NAME OF PROJECT:  
CATHEDRAL HIGH SCHOOL  
4-PAC PORTABLE ADDITION  
LOCATION:  
30 Wentworth St N, Hamilton, ON L8L 8H5

ISSUED FOR ADDENDUM 2 2025-05-01

CATHEDRAL HS  
PROPOSED 4-PAC  
PORTABLE CLASSROOM  
ADDITION

SITE PLAN &  
OBC MATRIX

SCALE: AS NOTED	PROJECT: <b>24057</b>
START DATE: MAR 2025	
DRAWN J.M.	DRAWING: <b>E1.00</b>
CHECKED J.M.	
PRINT DATE 05/02/25

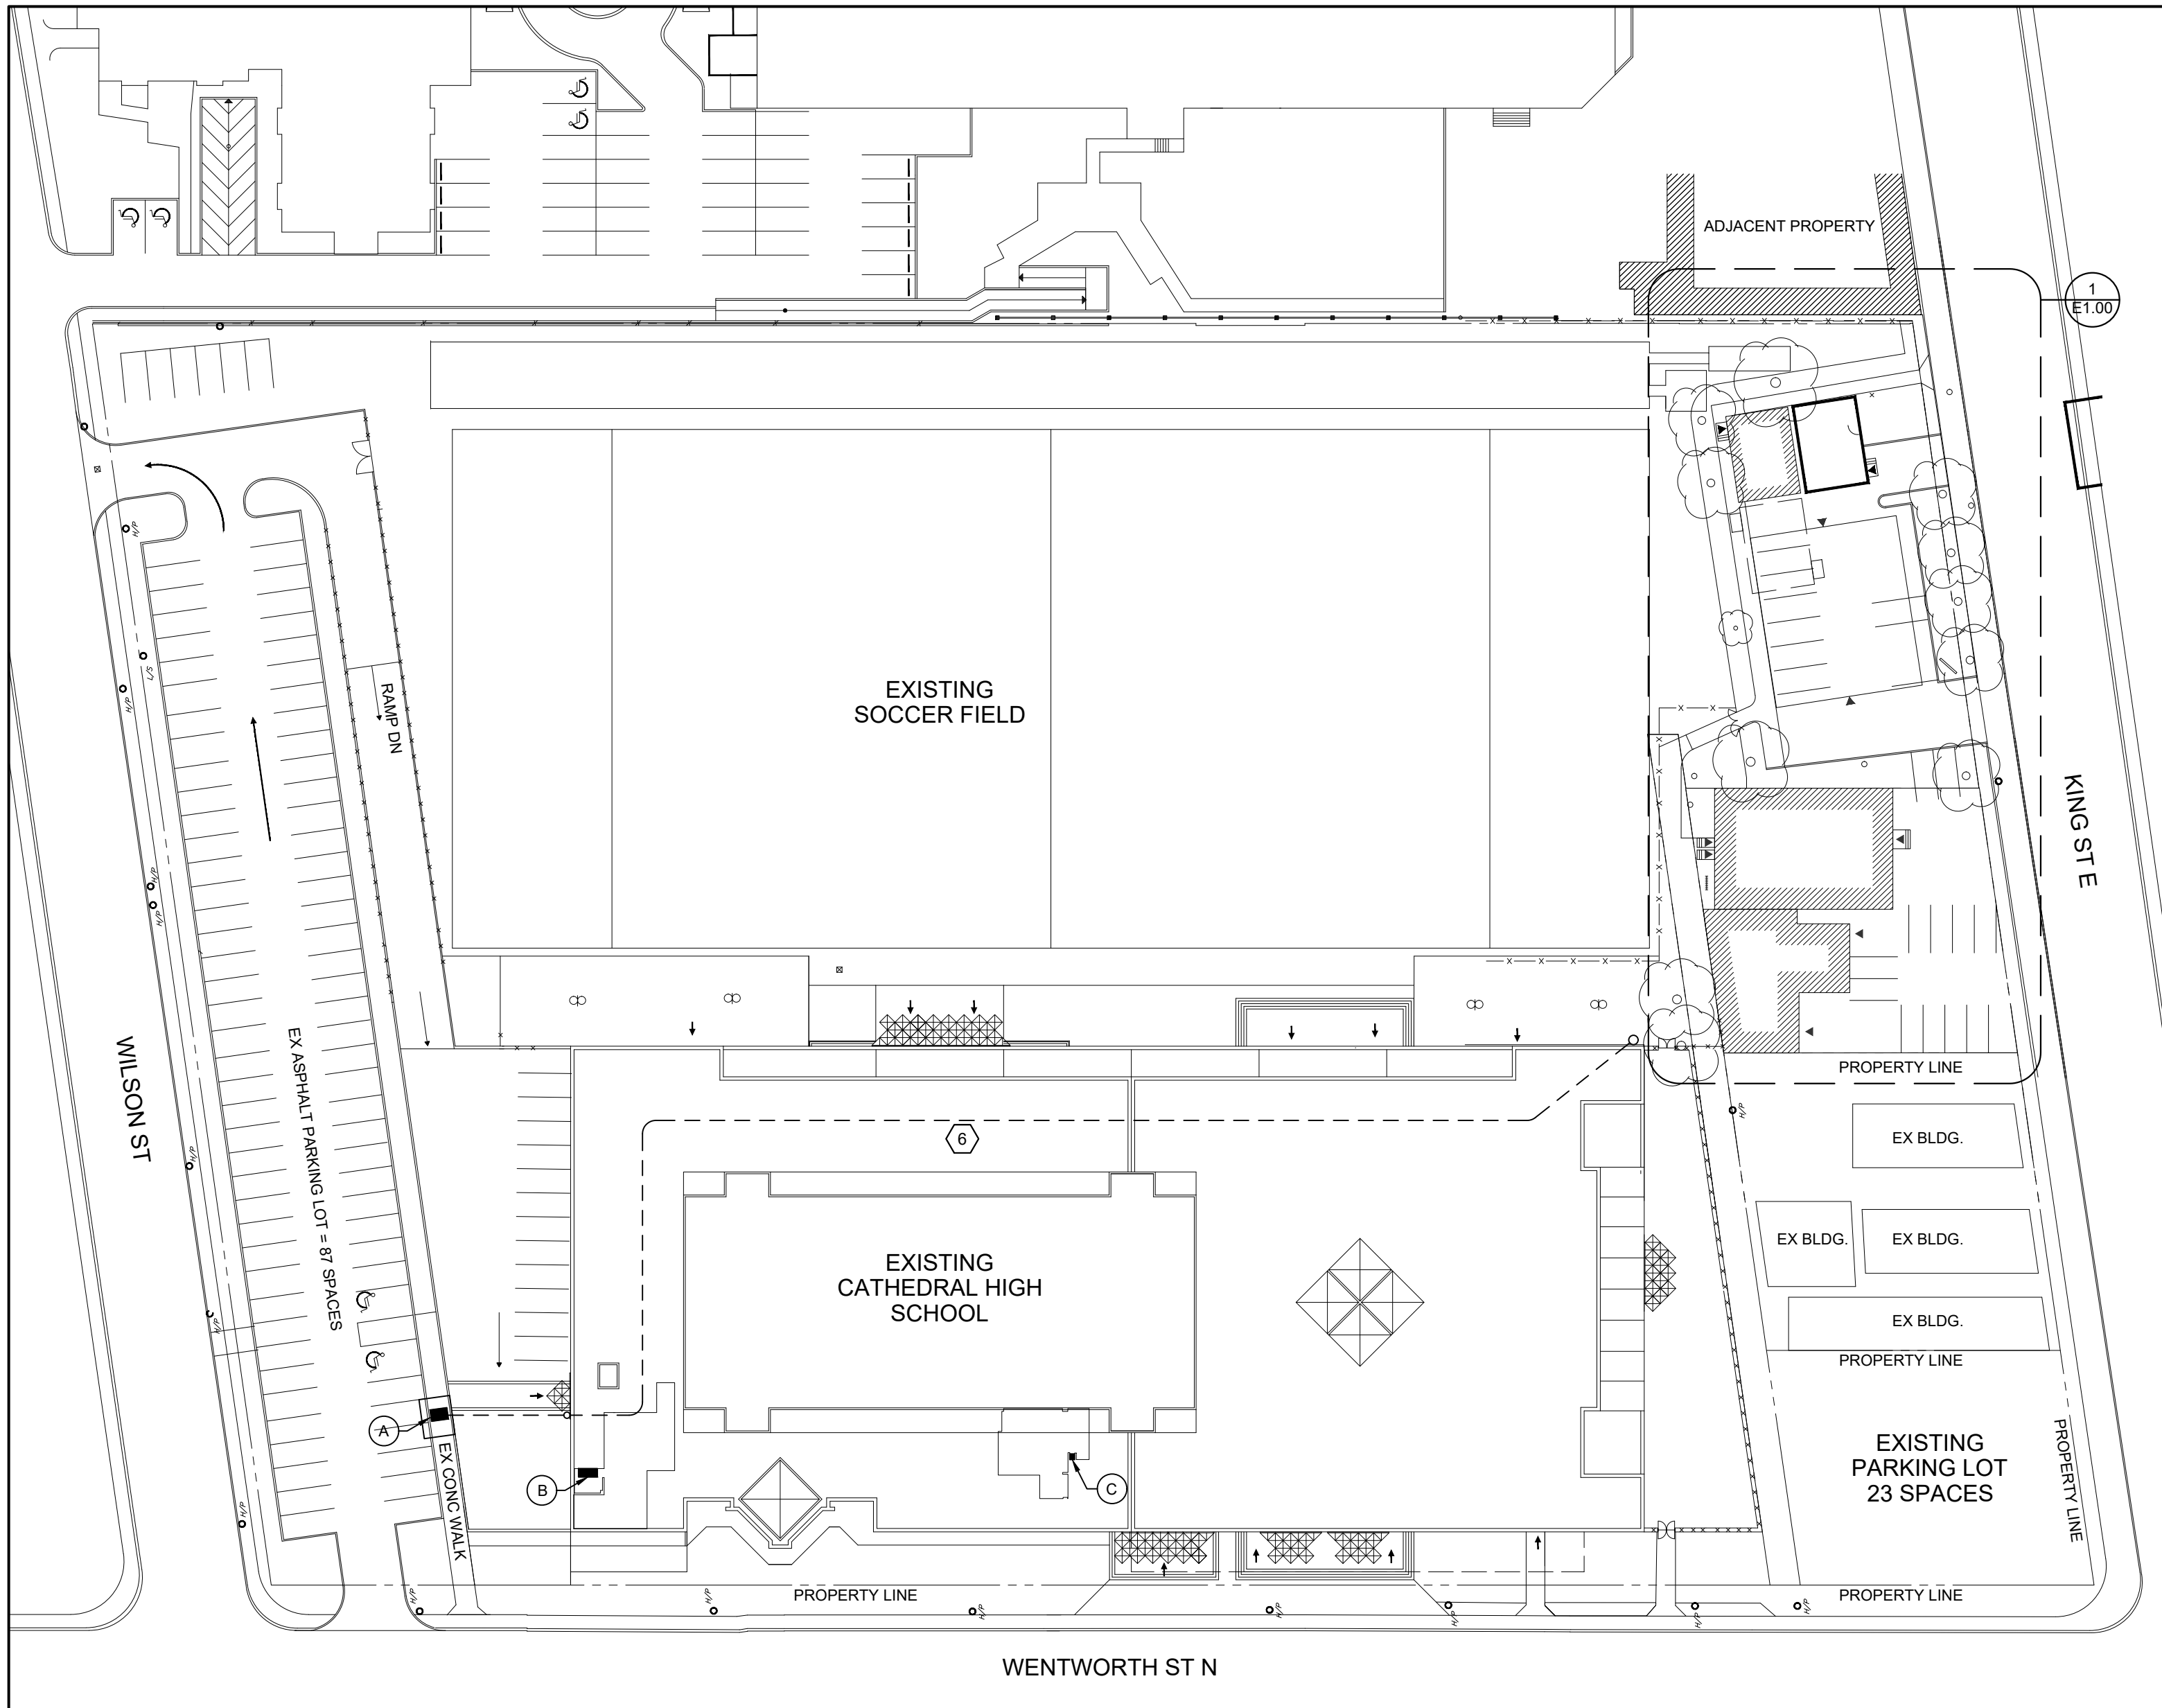
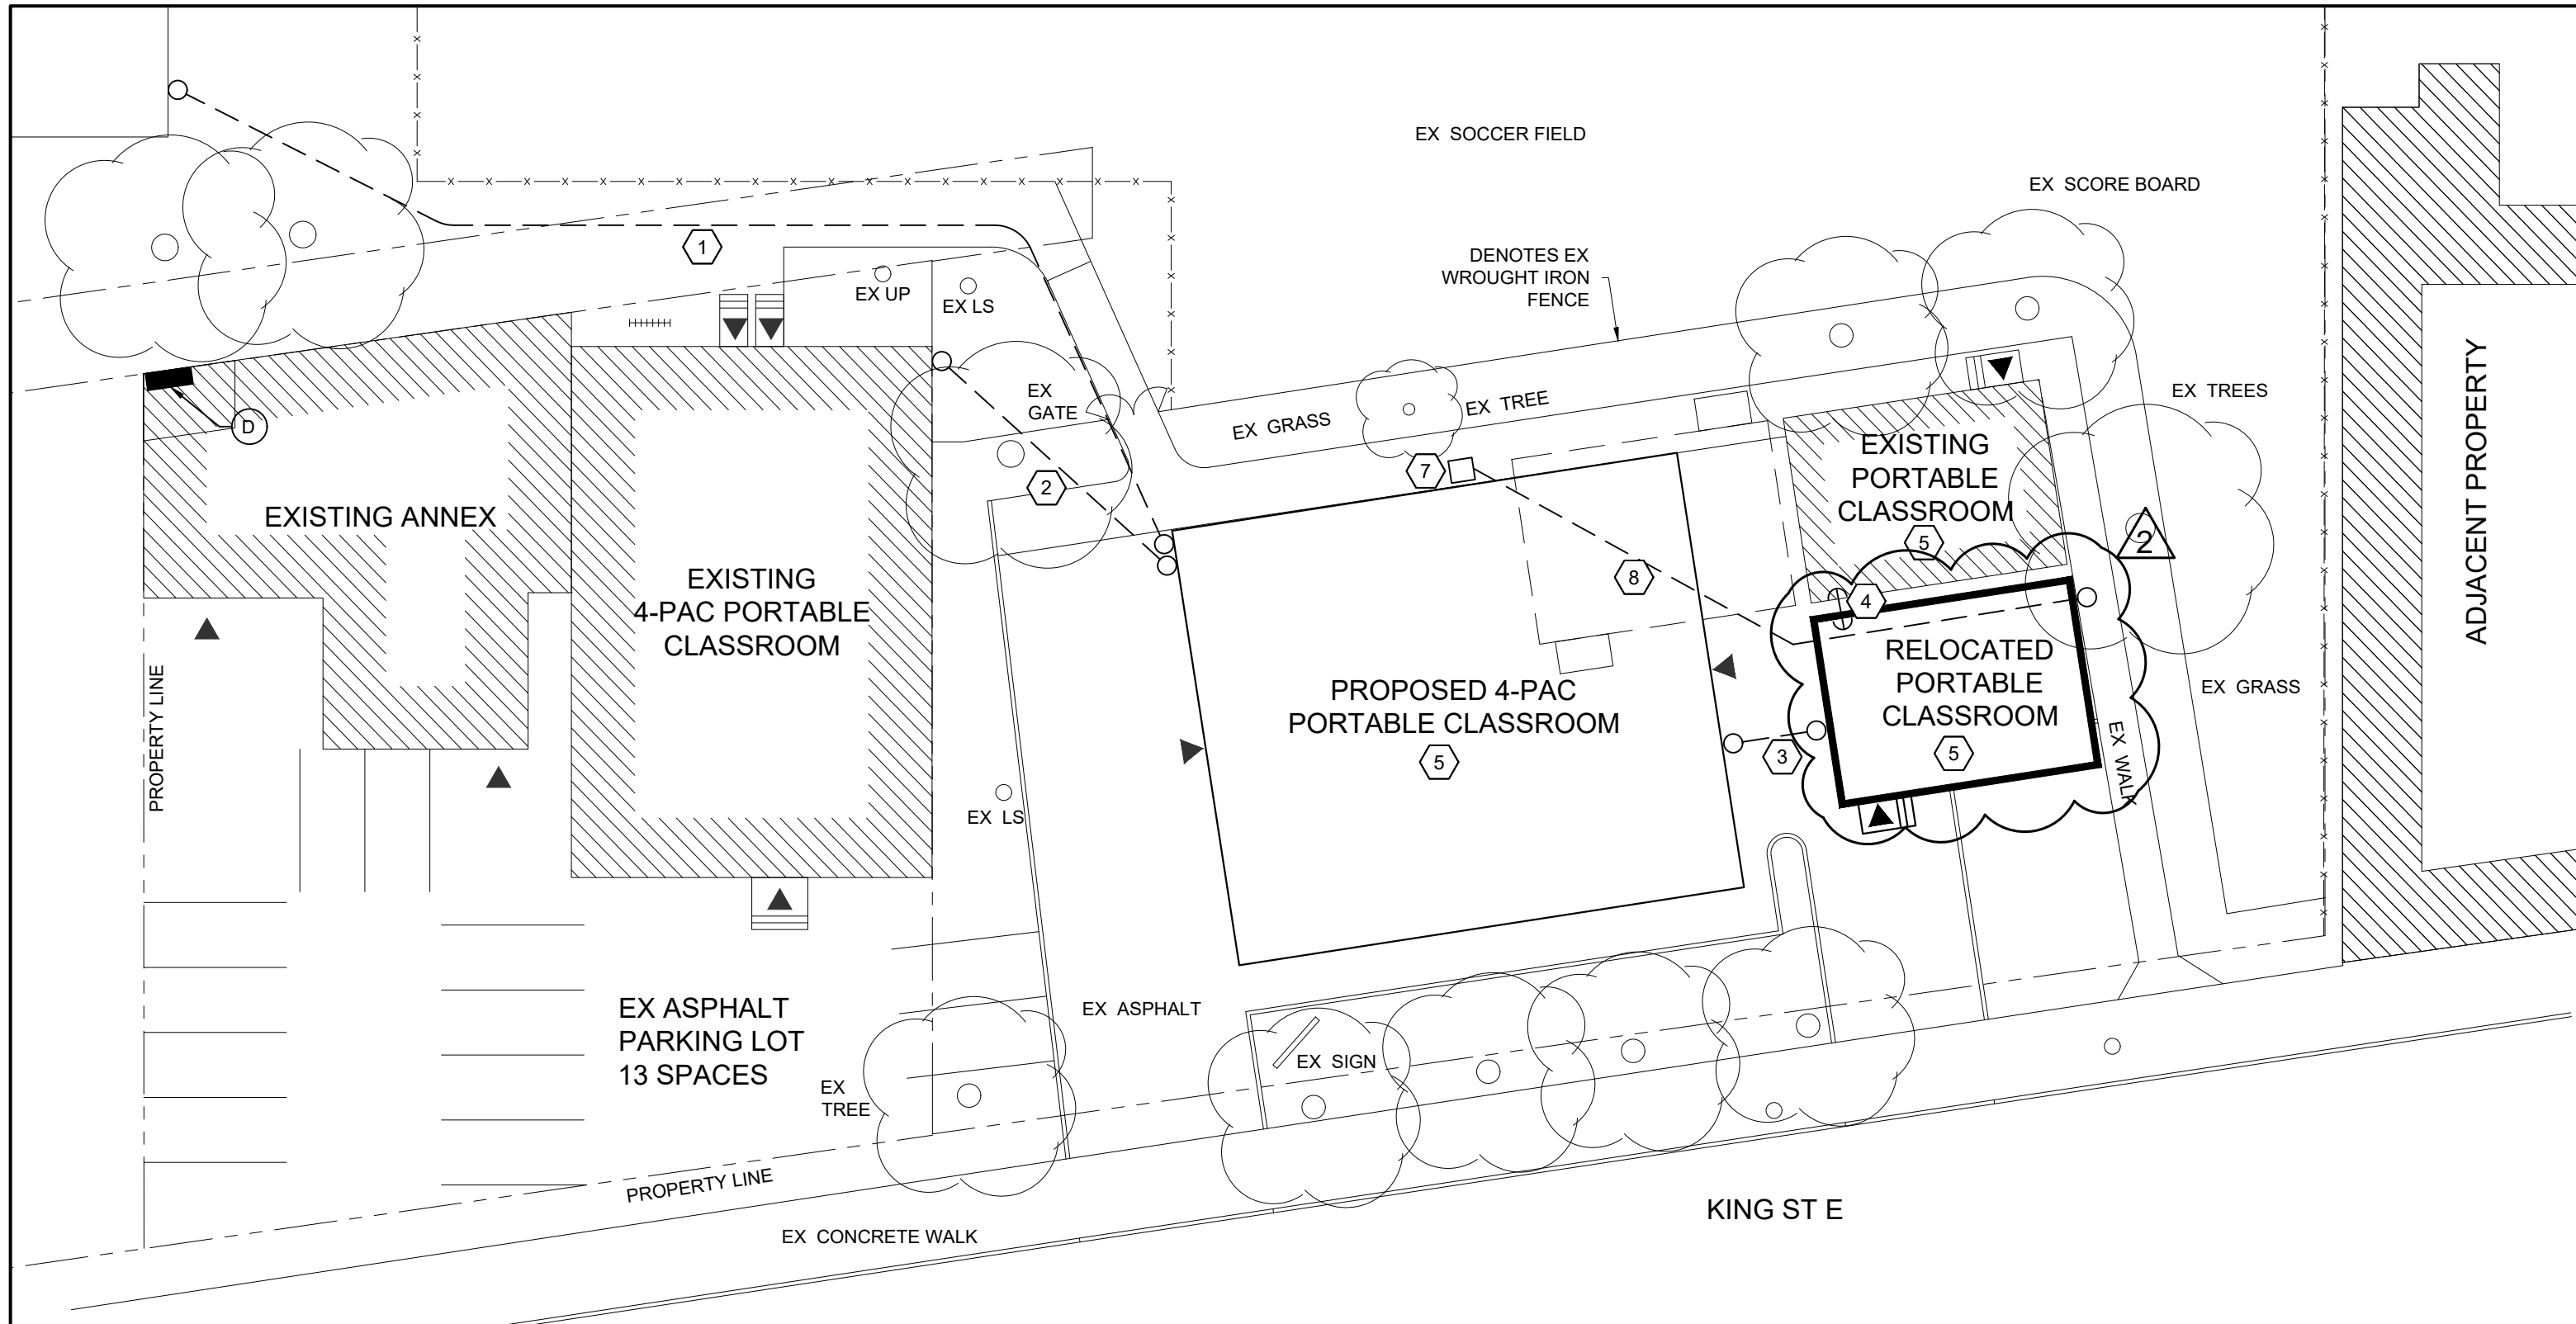
- Item 1**      Refer to attached revised drawing E1.00 Electrical Site Plan, in reference to the single portable placement revision of this addendum.
